Re: Application for a Works Approval (App-0026911) under the *Environmental Protection Act 1986* – Request for further information

Roy Hill Infrastructure Pty Ltd received a request for further information from the Department of Water and Environmental regulation on 29 January 2025 for the proposed expansion of the current Roy Hill Port Bulk Handling Facility and Screening Plant. Responses to Schedule 1 of the request for further information have been provided below. Relevant documents have also been provided as electronic attachments.

Figure 1: Hydrocarbon storage areas

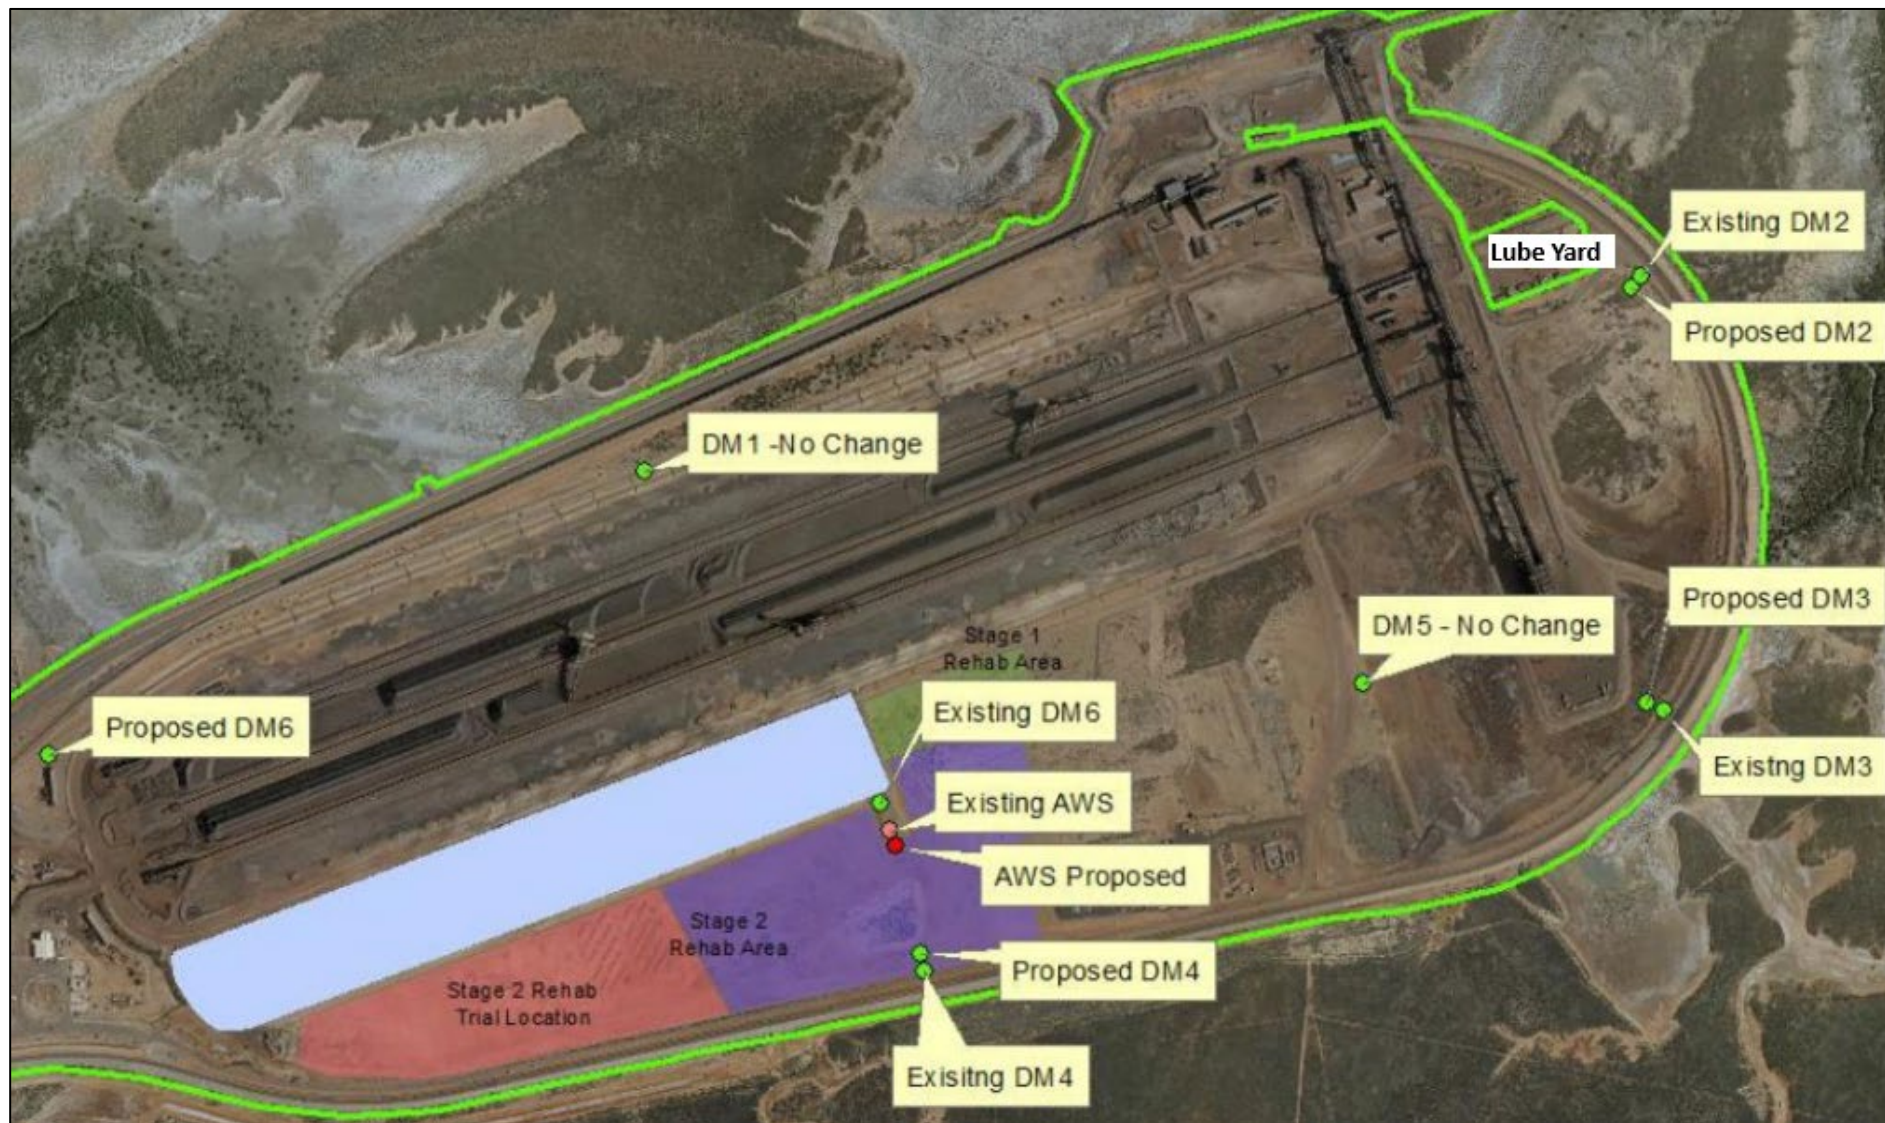
No.	DWER Information Required	Hanroy Response
3	<ul style="list-style-type: none"> • Please provide further detail on the information provided regarding the hydrocarbon storage on the trestle jetty, specifically: <ul style="list-style-type: none"> ○ the proposed volumes of hydrocarbons stored on the jetty, ○ specific management actions for spills etc., and ○ a map or diagram showing the proposed location of hydrocarbon storage areas. 	<p>Some small amounts of grease are stored on the wharf at conveyor 163/164 during shutdown only. These are stored on appropriate bunds (Figure 1).</p> <p>Spills will be handled as per the current spill and management procedure. Spill kits are present at each drive station.</p>
3	<ul style="list-style-type: none"> • Please clarify if you are proposing to construct / install new transfer stations as part of the proposed works. Details of the location and nature of any new transfer stations is requested, along with detail on any dust control measures proposed. 	<p>Transfer stations that transfer ore from conveyor to conveyor will be sized to accept/contain the volume of material during belt rundown preventing product from spilling out of the transfer during a blocked chute event. The proposed locations of the Project transfer stations are shown in Figure 2.</p> <p>All transfer stations will contain a fully enclosed ore stream, to ensure the capture and containment of potential dust emissions, and include the flowing dust mitigation measures:</p> <ul style="list-style-type: none"> • For conveyor to conveyor transfers a “WEBA” chute design will be investigated. • Chutes will be designed to catch ore dribble and ore discharged from belt cleaners; • Dust tight covers to enclose the transfer chute; • Rubber dust curtains at the entrance and exit points of the transfer stations will minimise airflow through the transfer point and reduce dust; • Primary and Secondary scrapers will clean the dirty side of the belt; • Rubber dust skirt to provide a seal between the moving conveyor belt and the chute; • Dual rubber dust curtains prior to the impact area a minimum of 150 mm apart • Dust curtain will also be provided behind the hard skirts; • Rubber dust curtains at the belt discharge will be separated by a suitable length to enable the dust to settle;

Figure 2: Dust control locations

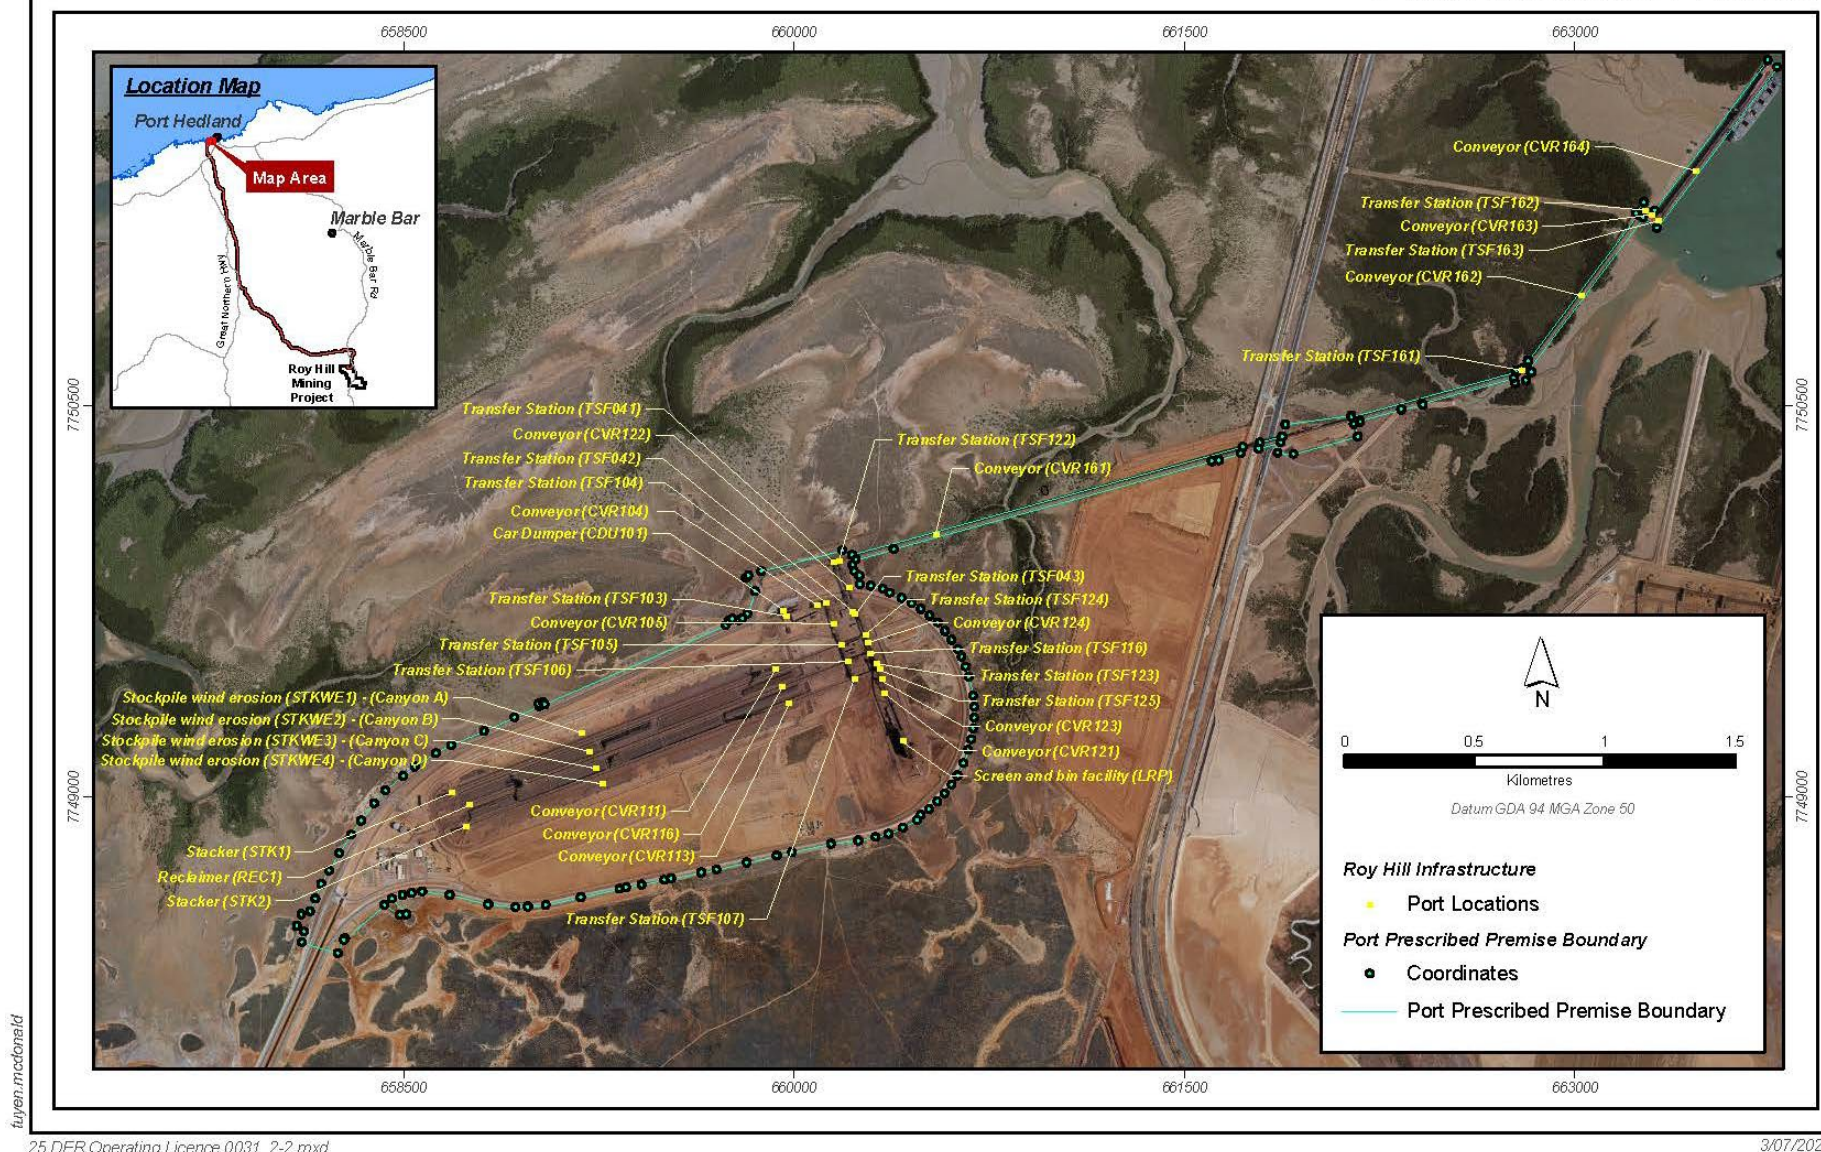
No.	DWER Information Required	Hanroy Response
	<ul style="list-style-type: none"> • Please provide additional detail on the nature of the proposed conveyor shielding (extent, material, coverage, etc.) particularly for the additional overland conveyor, understood to be constructed on top of the existing overland conveyor • Please provide additional detail on the number and location of belt scrapers and/or belt wash stations proposed for the new conveyors and where these will be located on a map, if possible. • Please provide detail on sprinkler reach and configuration (including number of sprinklers) associated with the additional stockyard footprint. The application indicates that the stockpiles will have an increased footprint (8m wider), and therefore additional information is required to confirm the dust control measure and strategies for this area, noting that open air stockpiling, stacking and reclaiming will likely increase dust emissions from this area. • Please provide additional detail on the controls proposed to manage dust for the new stacker and reclaimer (number and location of dust suppression sprays, etc.). • Please identify the specific dust suppression controls proposed for any additional transfer stations proposed. • Please identify the specific operational dust suppression controls proposed for the car dumper. • In the response to the above, a map/plan showing the location of all dust controls associated with the product handling such as the location of covers/hoods/skirts, belt washing stations, wind guards, dust suppression sprays etc. should be provided where possible. 	<p><u>Stockpile area</u></p> <p>The stockpile area dust mitigation system includes:</p> <ul style="list-style-type: none"> • Water cannons installed parallel to each row of stockpiles that are positioned to suit water spray trajectory, height, and slope of stockpile. The water cannon is fully automated with an associated wind anemometer and manual override capability. • Dust suppression water sprays on the boom (stacker) and wheel bucket (reclaimer). <p><u>Stacker and Reclaimer</u></p> <p>The stacker's water spray will be located at the boom discharge to spray the outer surface of the ore stream as it discharges onto the stockpile. Wind hoods will be fitted at the stacker boom discharge to direct the water spray onto the ore stream.</p> <p>The reclaimer water spray will be located on the bucket wheel positioned to wet the stockpile at the digging face. Water sprays will be installed on the reclaimer boom conveyor (prior to discharge into the central chute) and at the end of the yard conveyor loading zone.</p> <p><u>Transfer Stations</u></p> <p>All transfer stations will contain a fully enclosed ore stream, to ensure the capture and containment of potential dust emissions, and include the following dust mitigation measures:</p> <ul style="list-style-type: none"> • For conveyor to conveyor transfers a "WEBA" chute design will be investigated. • Chutes will be designed to catch ore dribble and ore discharged from belt cleaners; • Dust tight covers to enclose the transfer chute; • Rubber dust curtains at the entrance and exit points of the transfer stations will minimise airflow through the transfer point and reduce dust; • Primary and Secondary scrapers will clean the dirty side of the belt; • Rubber dust skirt to provide a seal between the moving conveyor belt and the chute;

No.	DWER Information Required	Hanroy Response
		<ul style="list-style-type: none"> • Dual rubber dust curtains prior to the impact area a minimum of 150 mm apart • Dust curtain will also be provided behind the hard skirts; • Rubber dust curtains at the belt discharge will be separated by a suitable length to enable the dust to settle; • Fitted with misting sprays (fogging system) at the transfer chute exit where required. • Inspection and access doors with a batten down latching device sealed with dust-tight gaskets; and • Regular maintenance to compensate for any wear that occurs. <p><u>Car Dumper</u></p> <p>The CD2 facility will be fully enclosed (except where train enters and exits) and contain a negative pressure system for dry dust extraction together with a collection system (bag house). Dust collected within the bag house dust extraction system will be treated and discharged back into the ore stream.</p> <p>Within the CD2 facility:</p> <ul style="list-style-type: none"> • Apron feeders directly below the Dump hoppers will extract the ore and transfer it to stockyard feed conveyor. A dribble conveyor will be provided underneath the apron feeders to collect material that falls between the apron feeder pans and direct it to the stockyard feed conveyor; and • A stockyard feed conveyor will transfer ore from the CD2 facility to the stockyard and is equipped with a moisture analyser. <p>Any spillage will be manually removed from the CD2 facility floor as a part of the general maintenance plan.</p> <p>A map/plan showing the location of all dust controls associated with the product handling such as the location of covers/hoods/skirts, belt washing stations, wind guards, dust suppression sprays etc. are provided below in Figure 2.</p>

Figure 4: Discharge pipeline (red dotted line)

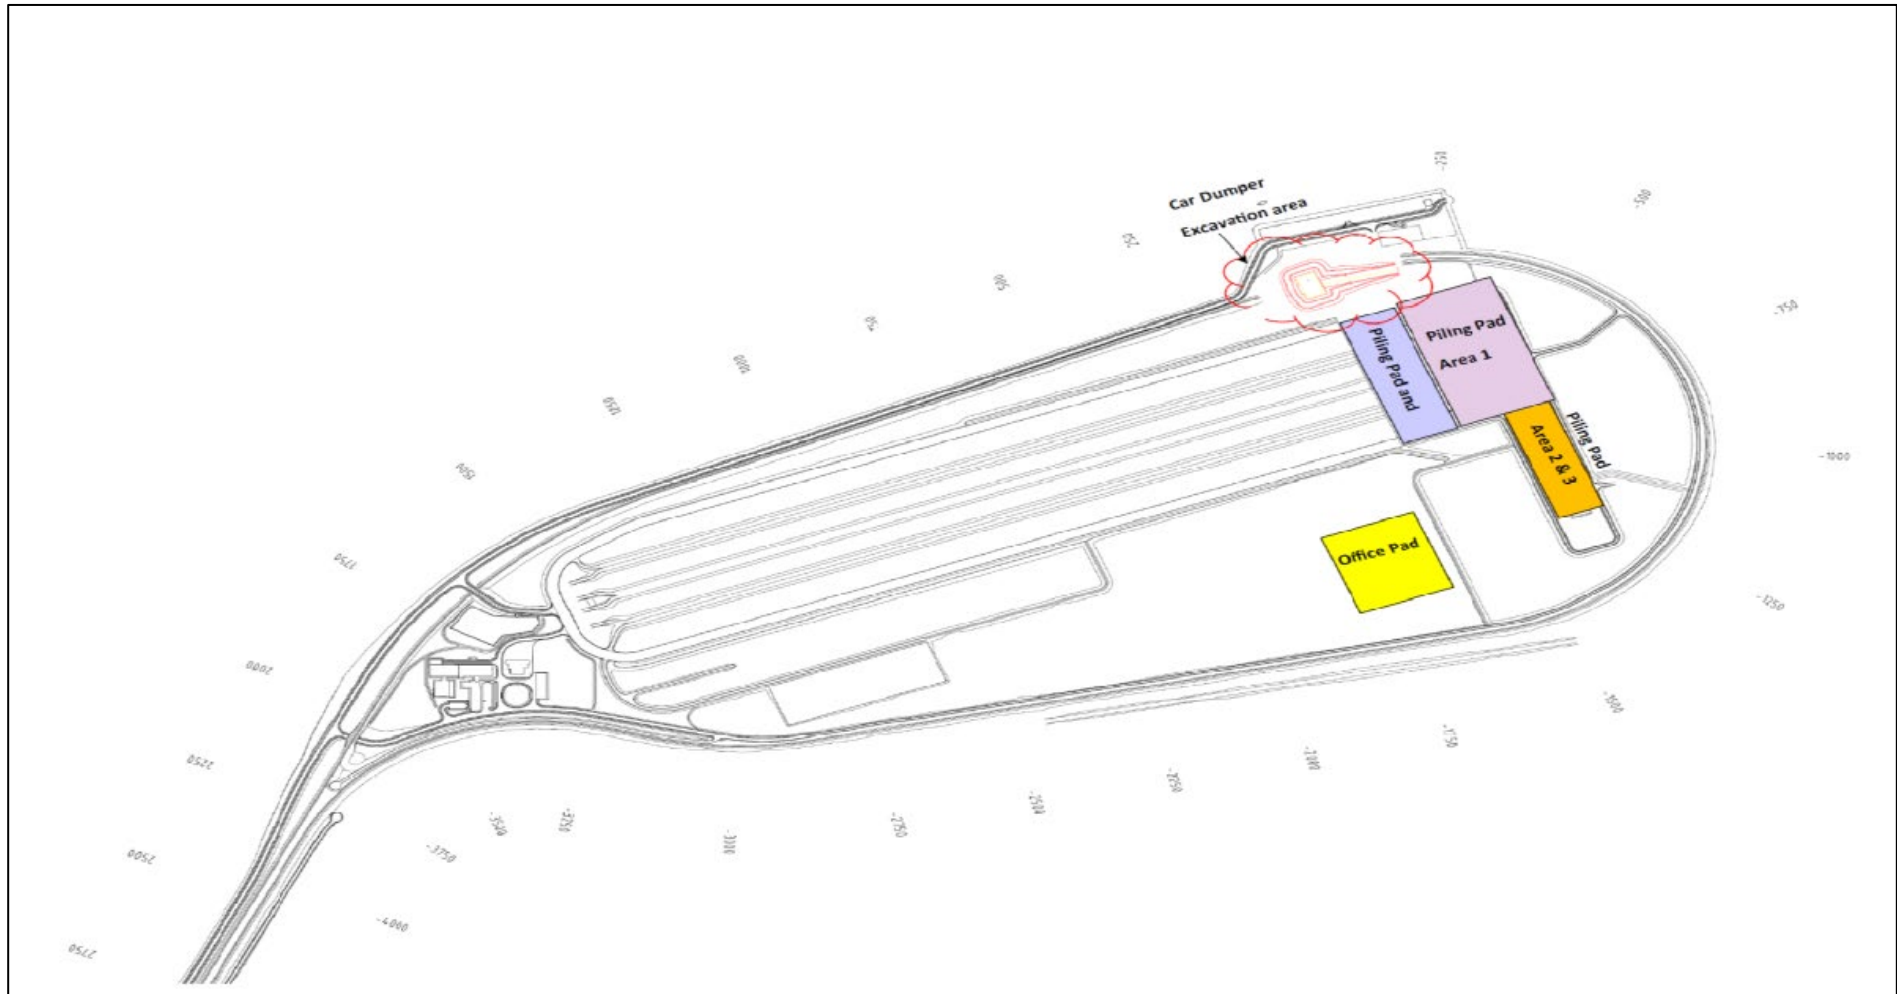
No.	DWER Information Required	Hanroy Response
	<ul style="list-style-type: none"> ○ construction (noise, dust, stormwater, management of ASS/PASS during excavation works, soil/waste disposal, dewatering requirements (discharges and controls, including consideration of likely dewater volumes, potential contaminants, discharge locations and the management of dewatering activities to mitigate the risks to the receiving environment/location), etc.), and ○ operation (noise, dust, hydrocarbon management etc.) 	<p>and it has been assessed under Part IV. However, in the interest of full disclosure the below information has been provided to address the potential emissions.</p> <p><u>Noise:</u></p> <p>Noise emissions have been estimated using the existing Port infrastructure. They are not expected to be excessive and will be reminiscent of the current Project operations. Noise will not impact receptors as the nearest receptor, approximately 6 km southeast of the activity and will cause no net increase in the received noise levels in the Town of Port Hedland.</p> <p>Prior to construction activities Construction Noise Management Plans will be prepared by contractors if works are to occur outside the hours 0700 - 1900 (Mon-Sat) and to comply with the Environmental Protection (Noise) Regulations 1997. Incident reporting will be maintained to assist in managing environmental incidents such as excessive noise emissions.</p> <p><u>Dust:</u></p> <p>Dust emissions have been estimated using the existing Port infrastructure. They are not expected to be excessive and will be reminiscent of the current Project operations. Dust emission modelling (Attachment 8B) shows that the maximum predicted dust emissions generated from the Project will not increase the maximum predicted ground level concentration at the Taplin Street receptor.</p> <p>Dust monitoring will be conducted as per the current Licence (L8967/2016/1). Opportunistic inspections for dust emissions will be undertaken during construction to ensure dust control measures are being implemented and are effective and visual inspections and incident reporting will also be conducted. A summary of relevant dust construction management measures has been provided below:</p> <ul style="list-style-type: none"> • Retrofitting of misting sprays within Transfer Stations will occur if it is determined that the dust monitoring trigger values are being exceeded. Extra monitoring will be established to localise the root cause of dust emissions prior to any engineering controls being installed;

No.	DWER Information Required	Hanroy Response																		
		<p>conveyor corridor to the berths (Figure 4). The lined holding time is designed to hold approximately 10,100 m³ (i.e., up to 16 hours of water discharged at a rate of 175 L/s). A diesel-generated mobile dewatering discharge pump skid with estimated 250 kW will have capacity to pump approximately 200 L/s to an approximately 4,000 m long HDPE pipe that runs along the existing conveyor structure (Figure 4).</p> <p>The pipe will extend to the wharf deck. The dewater will be discharged at depth into South West Creek through the two outfall pipes attached to two wharf piles. Each outfall pipe will have diffuser ports situated at minimum of 8 m below lowest astronomical tide. Discharge will be continuous at 24 hours a day, seven days a week.</p> <p>Continuous water quality monitoring will be undertaken when discharge is occurring. The guideline values for in-line discharge parameters are shown in Table 1. In the event of an exceedance the contingencies provided in Section 9.3 of Attachment 8I will be implemented.</p> <p><i>Table 1: Continuous dewatering outfall water quality monitoring</i></p>
